**COUNTY OF WESTCHESTER
NEW YORK
DEPARTMENT OF PUBLIC WORKS
AND TRANSPORTATION
DIVISION OF ENGINEERING
ADDENDUM NO. 2
CONTRACT NO. 23-519
FOR
ROOF, HVAC, AND ELECTRICAL UPGRADES
DANIEL P. THOMAS MATERIAL RECOVERY FACILITY
YONKERS, NEW YORK**

**CONTRACT NO. 23-519
ROOF, HVAC, AND ELECTRICAL UPGRADES
DANIEL P. THOMAS MATERIAL RECOVERY FACILITY
YONKERS, NEW YORK**

Sketch

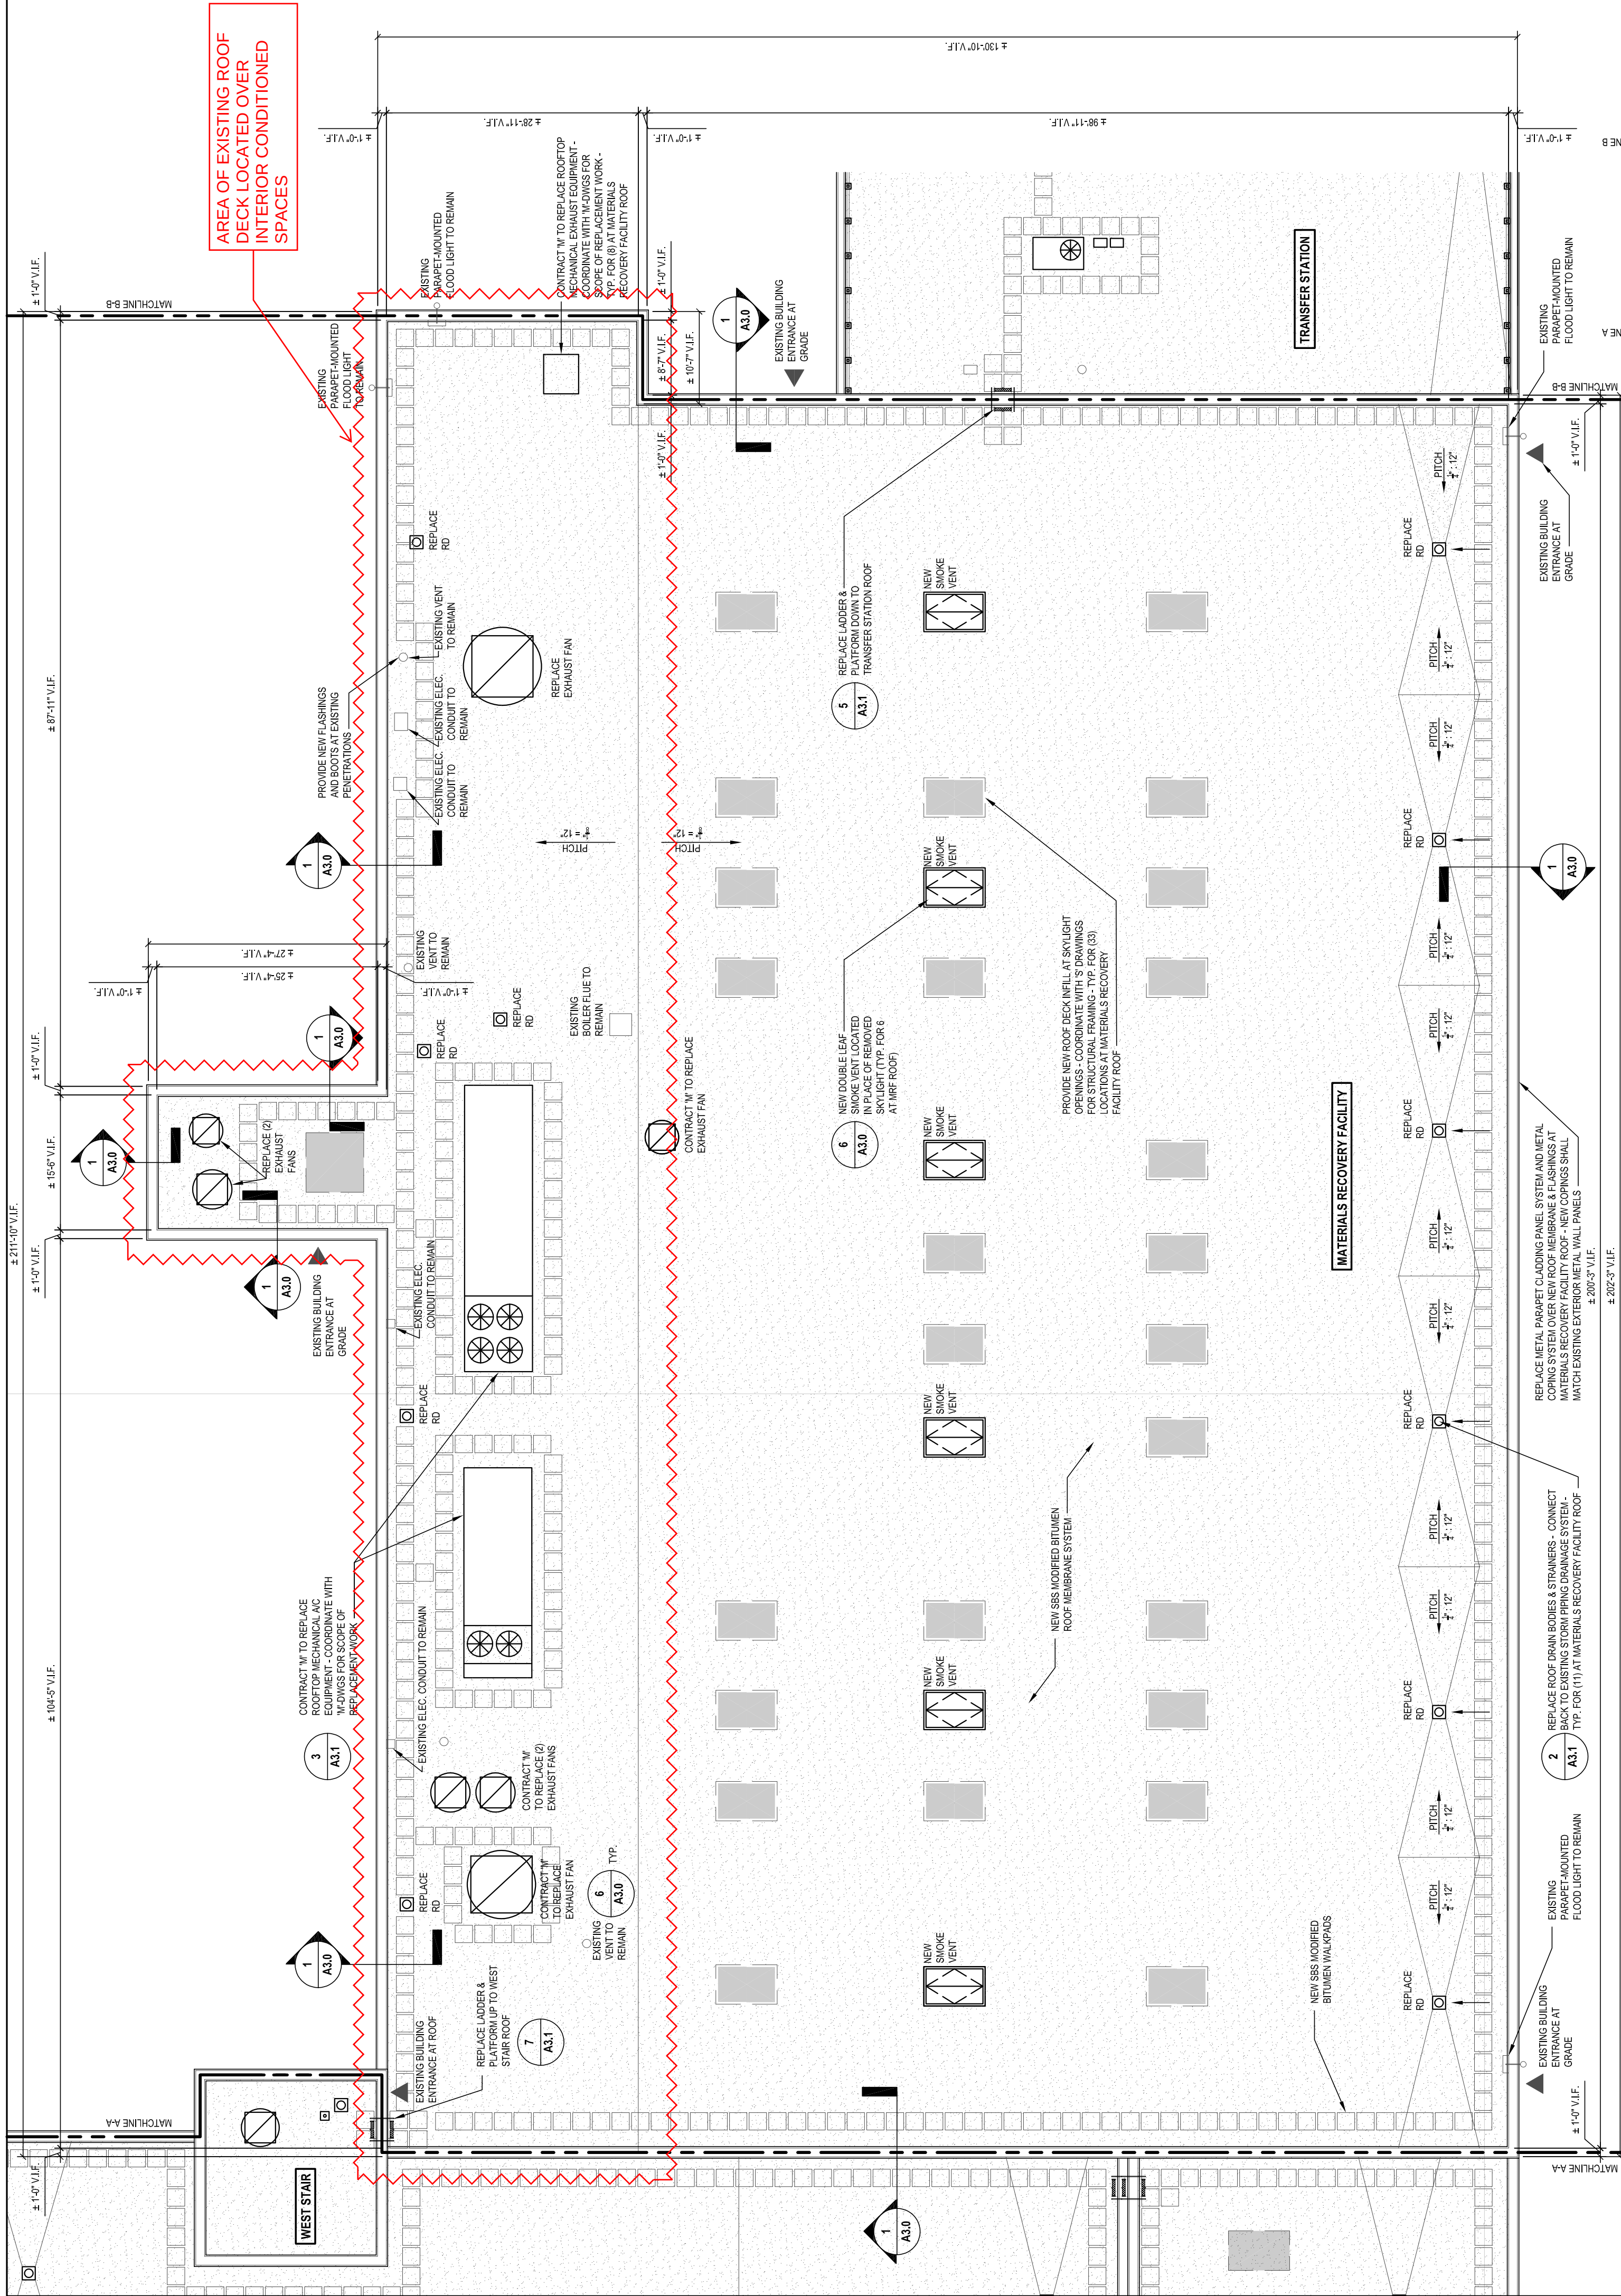
5. “The new roofing system is going to have R-30 insulation which is about 5.5” thick plus cover board .5”, the current system is about 1.5”-2” thick. This will create flashing issues at the items shown in the pictures. Please clarify how address the flashing heights. See picture 5996 short wall height, picture 6012 existing ventilator to remain has no flashing height, picture 6022 shows existing insulation thickness.”

❖ Replaced roofing system over conditioned interior spaces shall provide minimum R-30 continuous rigid insulation entirely above the deck, as required by the 2020 Existing Building Code of NYS, the 2020 Building Code of NYS, and the 2020 Energy Conservation Construction Code of NYS. See attached Sheet A2.1 Sketch for identification of roofing areas which are located over conditioned interior spaces. Raise equipment curbs and/or additional edge blocking as required to perform the work. Bidder(s) shall field-verify the roofing system assembly at this area to confirm existing insulation thickness and shall report back to Architect/Engineer if the specified insulation build-up cannot be achieved.

❖ Roofs over unconditioned spaces (the MRF and transfer station tipping floors, the paper & shipping floors, and the baler building) are exempt from the building thermal envelope provisions of 2020 ECCCNY, Section C402. New rigid insulation boards shall be installed above the existing roof deck as required to replace removed materials in-kind and to yield a minimum 1/8”:12” pitch towards roof drains – new or replaced insulation build-up does not need to exceed the existing in thickness or height above the deck. The reinstallation or replacement in-kind of equipment curbs or supports, parapets and low wall shelves, metal wall panels, flashings, or copings/edge metal systems shall be modified as required to meet the minimum installation requirements of the roof membrane manufacturer.

Partial Roof Demolition Plan - Paper House & Shipping House

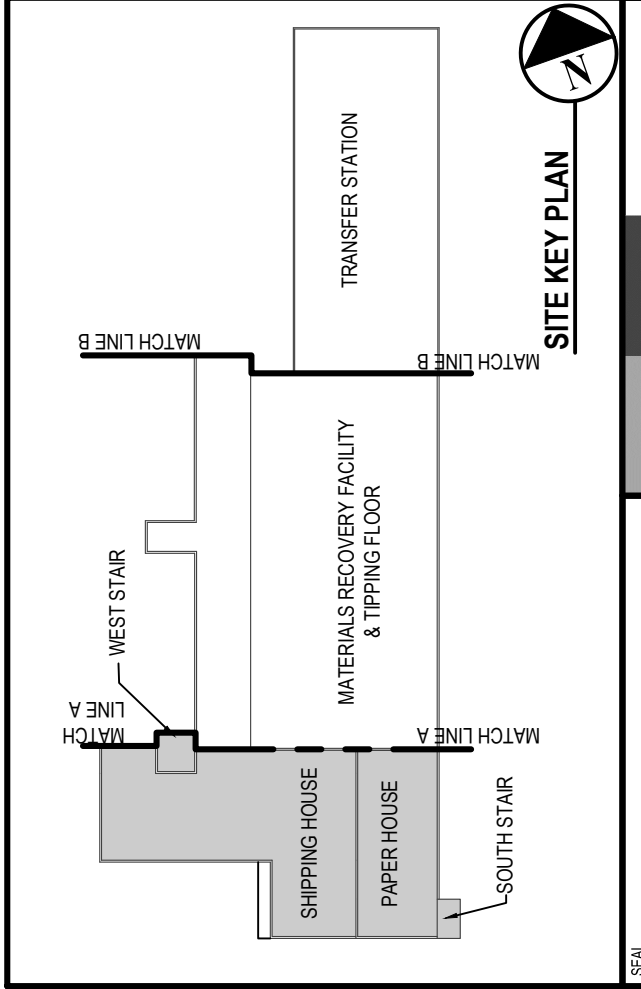
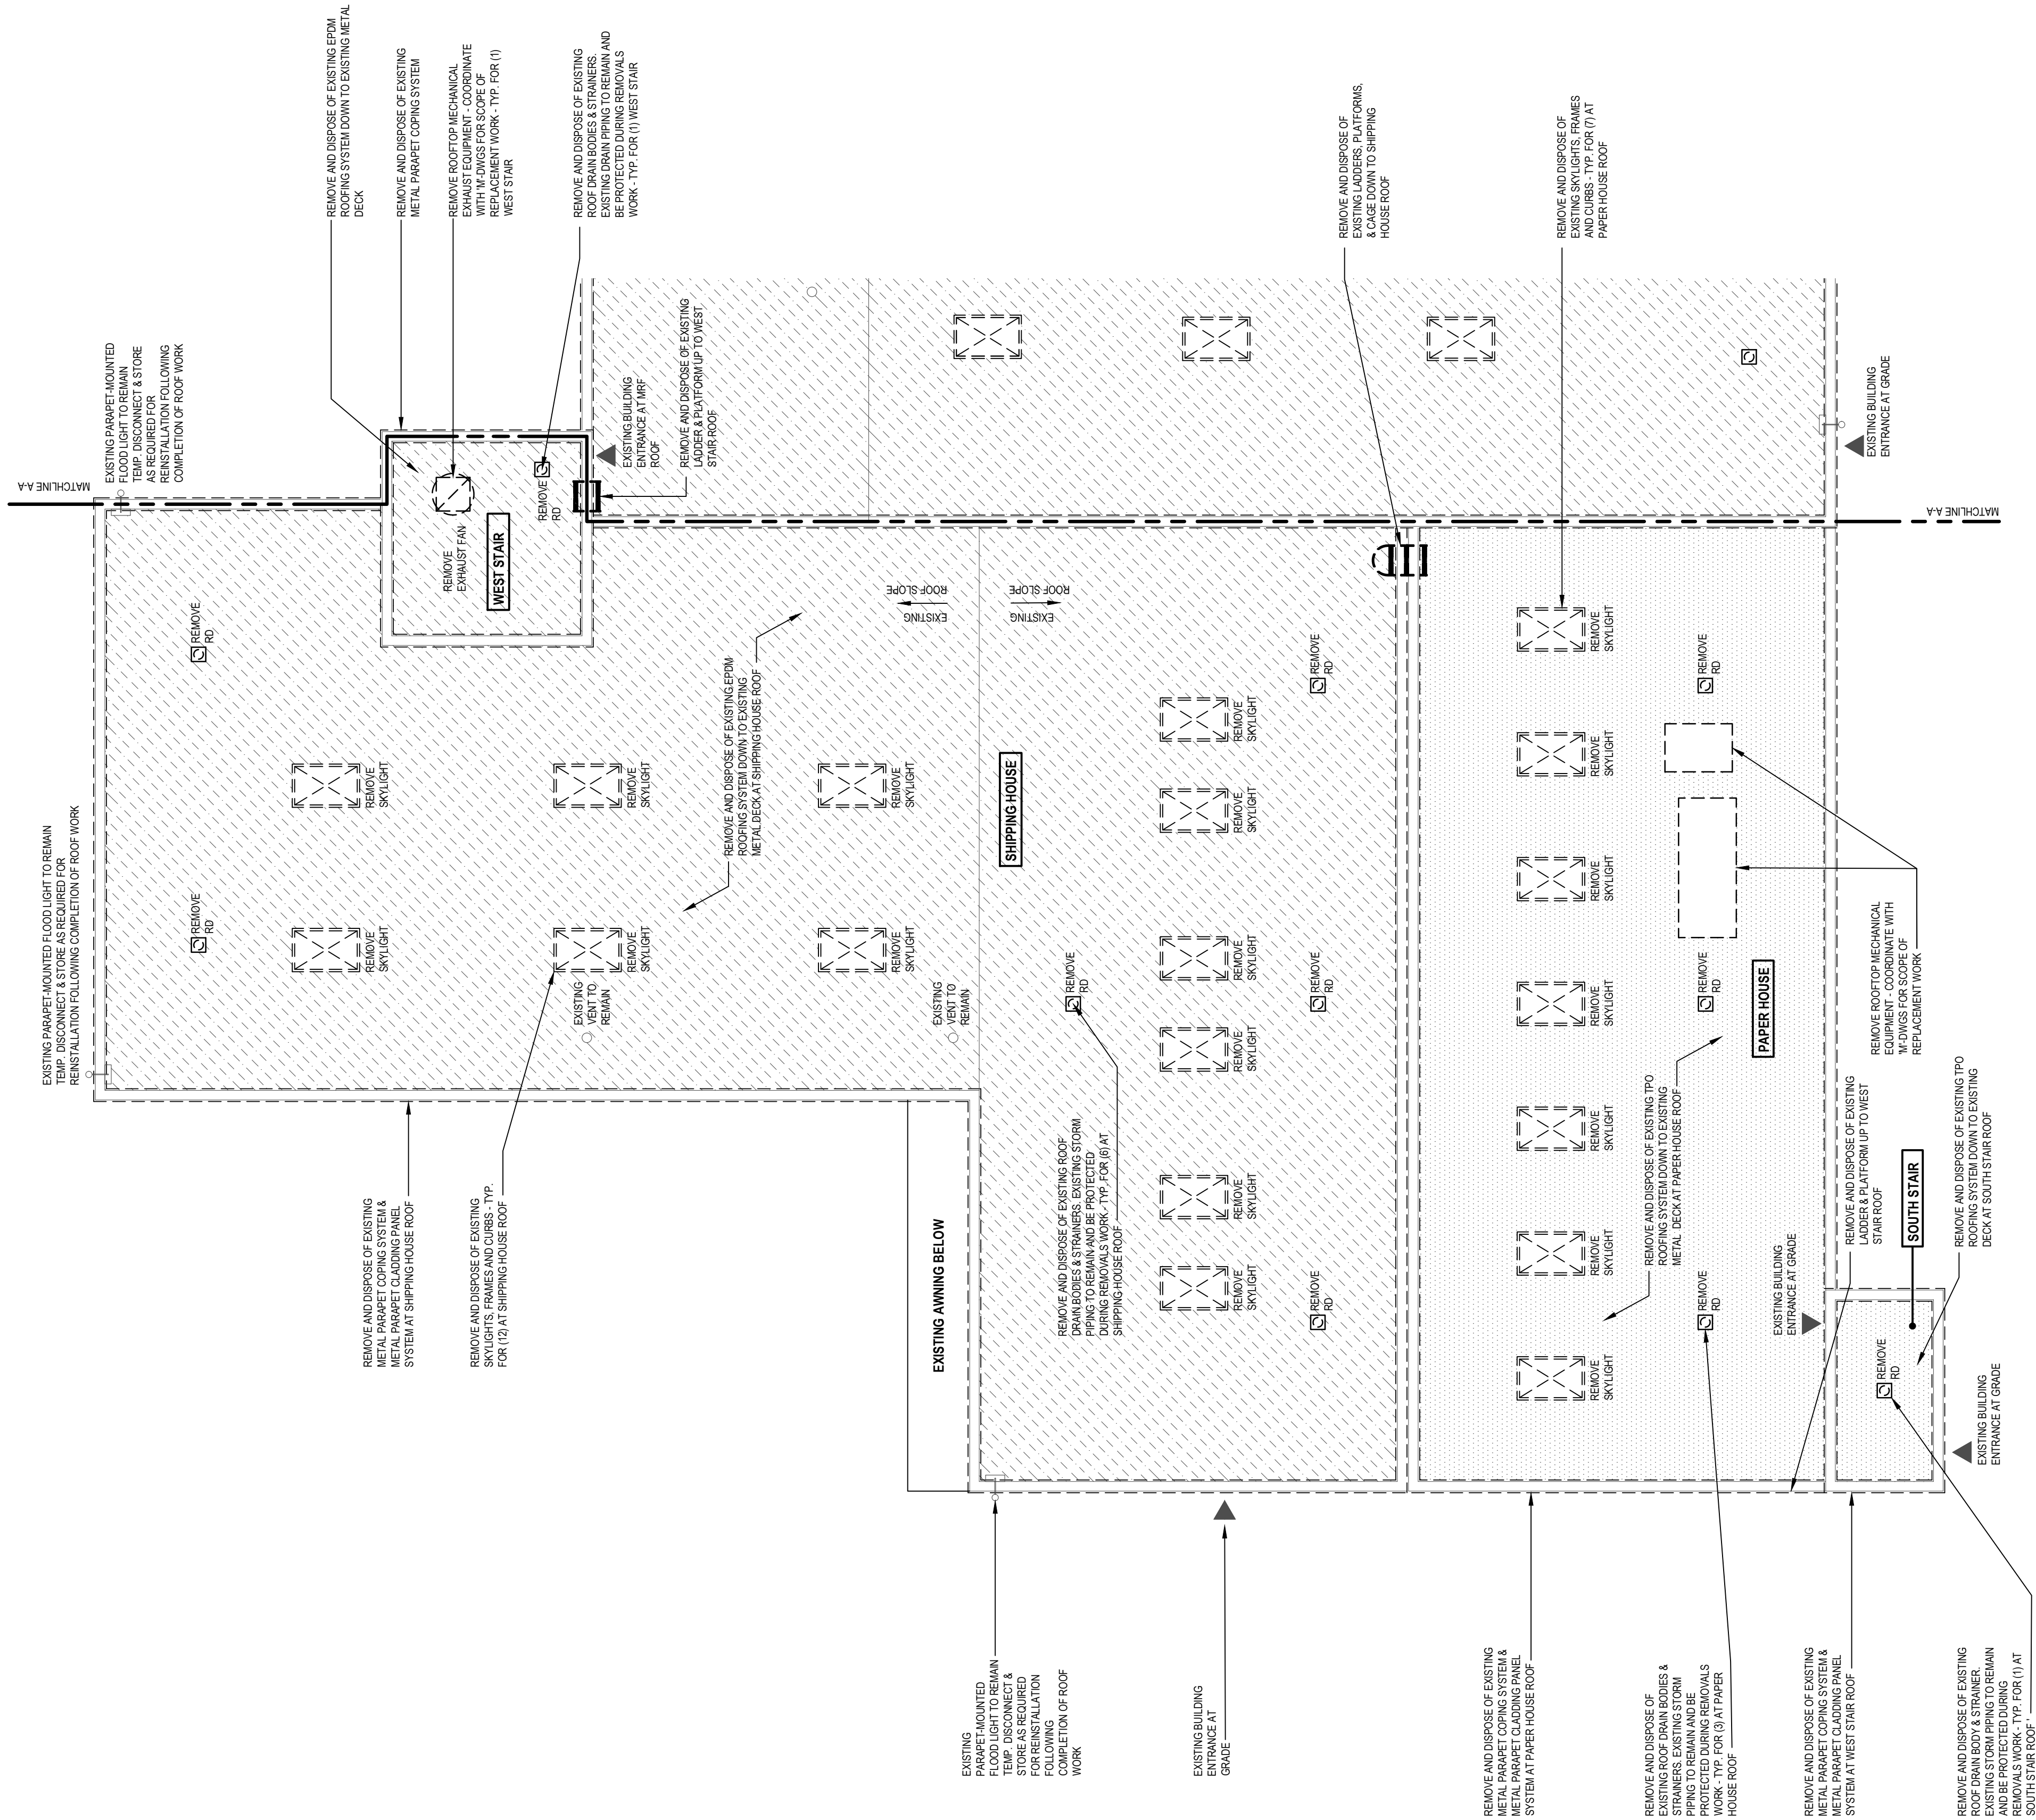
1. AD1.0:
 - ❖ **Miscellaneous annotations throughout are revised to remove references to Contracts ‘G’, ‘M’ and/or ‘E’. This project will be Single Prime. See attached.**

2. "As per drawing INF1.0, general scope of work notes mentioned multiple contracts (G, M & E). Please confirm if there would be multiple contracts or only single prime contractor will responsible for all scope of works for this project."

❖ This project will be Single Prime Contact. The drawing sheet INF1.0 is modified to clarify this. Other drawing sheets are also revised to remove references to separate Contracts (Sheets AD1.0, AD1.1, AD1.2, A2.0, A2.1, and A2.2). See attached.
